B65 931006 201

KINGSTON FOSSIL PLANT - INSPECTION OF THE WASTE DISPOSAL AREA

KINGSTON FOSSIL PLANT - INSPECTION OF ASH DISPOSAL AREAS

Picture 4- A slough that has  
been stable for four months.

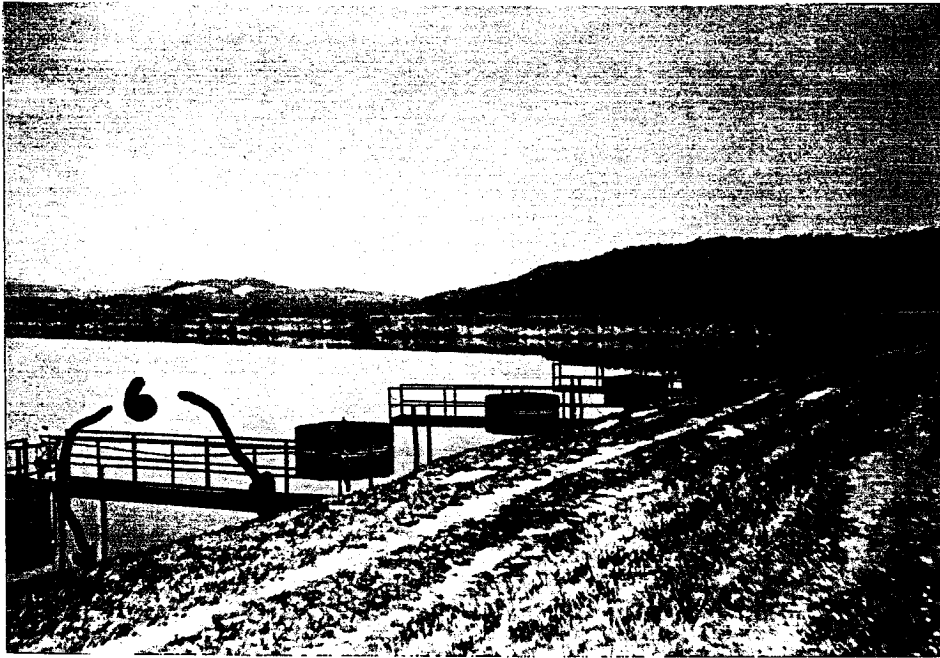
This appears to be a surface sluff caused by a temporary condition of water collecting and crossing the road from an area being prepared for retirement and is a structural problem.

- 6.1.1 The algae needs to be removed from the skimmer of the western most spillway on a continuous basis.
- 6.1.2 Riprap needs to be placed on the inside slope of the stilling pool dike, average 100 lbs., to stop the wave erosion.
- 6.1.3 Add riprap at the outlet end of the existing dike storm drains to correct the existing erosion and prevent additional erosion. The stones should be in the range of 40 to 80 lbs.
- 6.1.4 Additional drain pipes should be added to Dike C across the berms, see 10N420 for locations, (reference 2.1.4).
